**MINUTES OF THE MEETING**

**16 August 2001**

**16 Aug 2001 Project: Beacon Hill Library**

**16 Aug 2001 Project: People's Lodge**

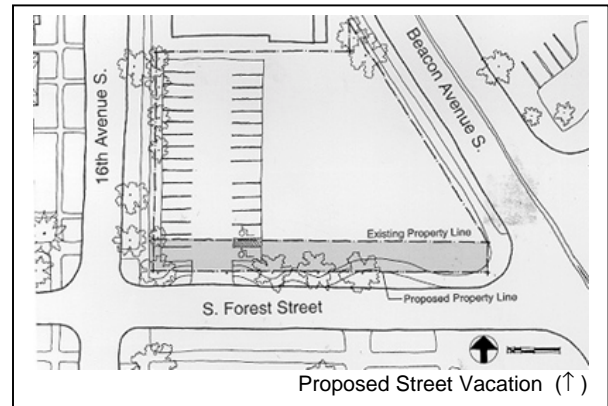
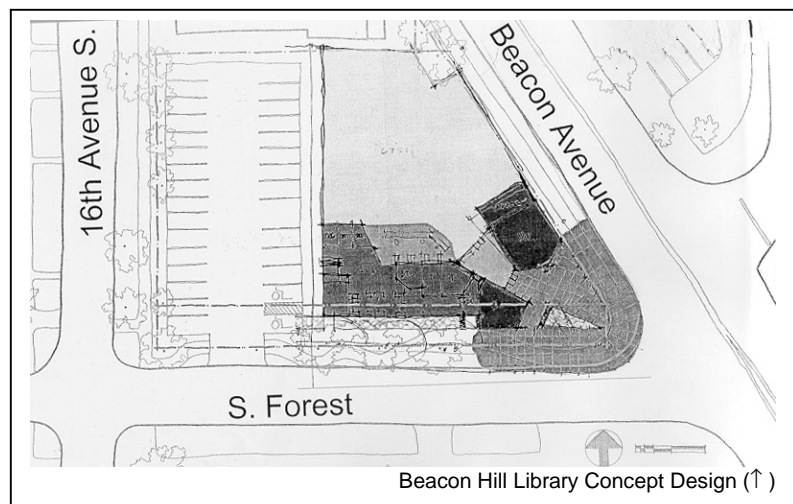
- suggests that, to further develop the sustainability of the design, the team should reduce the building footprint and surface parking lot area, perhaps putting the parking underground;

- to maintain the residential character of the neighborhood, encourages and strongly supports proponents' efforts to reduce the number of parking spaces by three or four;

- urges the team to propose an absolute minimum number of parking spaces required and seek a variance, to further encourage library patrons to identify alternative transportation options;

- in order to fully assess the need for a street vacation, asks the team to present an analysis of the urban design context, especially in relation to existing patterns of activity and pedestrian routes;

- at future Design Commission presentations, would like to the team to present alternatives, without a street vacation, that address the Commission's concerns about neighborhood context and preserving the pattern of green space along the street edge;

- urges the team to examine the effect of the proposed building edges and proposed sidewalk on the existing trees and their roots; and
- encourages the team to develop the massing and design of the entry corner at Beacon Avenue and South Forest Street to be that of significant and appropriate civic scale.

- Recognizes that the street edge of South Forest Street, west of the site, has a significant landscape buffer planting strip. Feels that this strip should be extended east though the site and believes that the depth of the landscaped edge should match that of the surrounding neighborhood.

- Recognizes that the entry plaza separates the meeting rooms. Believes that this creates a constraint, as the meeting rooms can never be combined to create a larger meeting space.

- Believes that there must be another design solution. Feels that the building footprint is large. Does not believe that this approach is sustainable, as it does not allow for expansion in the future. Would like to know if 30 parking spaces are required.

- Feels that the team has proposed a street vacation in order to meet the parking requirements. Would like the team to pursue a variance in parking requirements instead of a vacation.

- Does not believe that the trees along the curved sidewalk, on South Forest Street would survive the proximity of this construction.
  - Proponents stated that they would like to preserve the existing trees on the site, and the team will consult an arborist to determine the most effective solution.

may be widened. Agrees that the scale of the building is that of a big box. Would like to know why the roof slopes down to the entry. Encourages the team to make the entry and other public spaces as tall as possible.

- Is concerned that the design encroaches upon the sidewalk pattern. Encourages the team to respect the patterns and setbacks of the neighborhood. Respects the team's efforts to provide the required parking spaces, and hopes that the neighborhood will not be burdened by excessive on-street parking.

- Encourages the team to increase the height and visibility of the entry corner.
  - Proponents stated that they do plan to develop a prominent entry.
- Recognizing the parking lot at the rear, believes that many people would approach the building from the parking lot.

- Proponents stated that many of the adjacent buildings are two stories. Further stated that the height of the library would be that of a two-story building; the site is zoned NC-40. Further stated that the operating costs of a two-story library would be cost-prohibitive. The operating costs for a 10,000 square foot building would increase approximately \$300,000 to \$500,000 a year to provide the same level of service on all floors. Library staff must supervise the meeting rooms and all areas of the library.

- Proponents stated that the Land Use Code required 30 spaces. Further stated that the team would develop a proposal incorporating 25 spaces. Further stated that the parking requirement is determined by the Department of Design, Construction, and Land Use (DCLU) is based on expected demand.

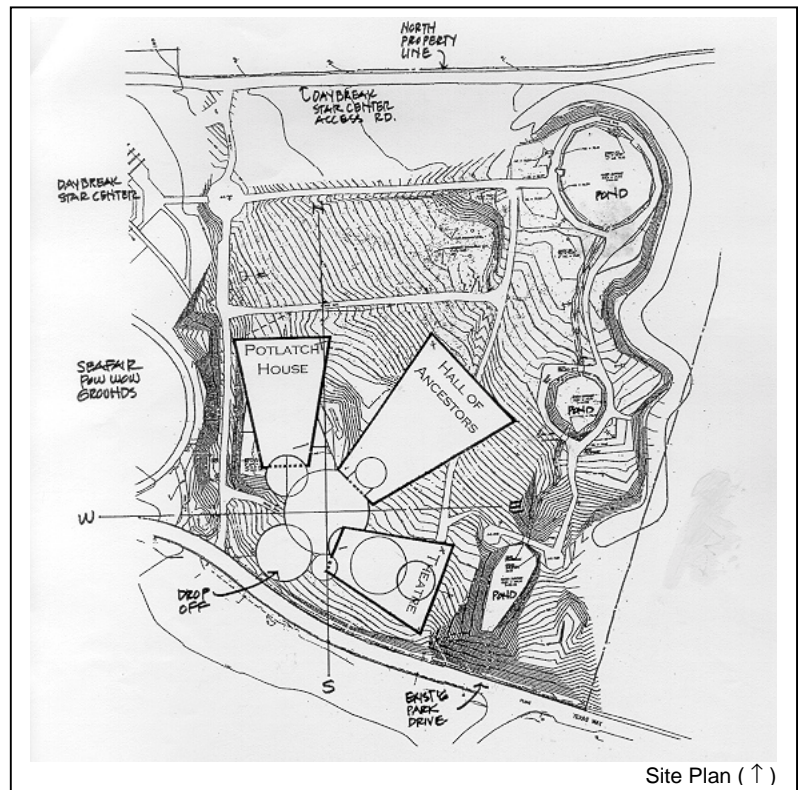
- supports the development of the design as three buildings, and believes that this approach is appropriate;
- encourages the team to soften the wedge shape of the buildings and develop the structural system to become an architectural expression on the exterior of the buildings;

- Strongly supports the efforts of the client and the design team and commends the proponents for the improvement in the conceptual design. Is concerned about the steep site and the grade change between buildings. Would like to know if the approximate forty-foot difference between the opposite corners of two buildings has been resolved.

- Proponents stated that this has been resolved through the design.
- Appreciates the eloquent description of the project, and the description of the land flowing between the buildings. Believes that the three buildings will appropriately frame the entrance. Appreciates the round gathering spaces, and would like to know why this design vocabulary is not expressed on the outside. Would like to know why, for three different program conditions, the three buildings are the same shape. Believes that a wedge shape is a natural theater space, and would like to know why the theater is a circle.

- Would like to know if the full wall behind the stage, facing the sloping land below, would be a blank wall.
  - Proponents stated that there would be some articulation in the façade, as the dressing rooms would be along this wall. Further stated that there are many design details that have not yet been developed.

- Proponents stated that the design team did explore different building massing, but this village of three wedge-shaped buildings was most appropriate for the site.
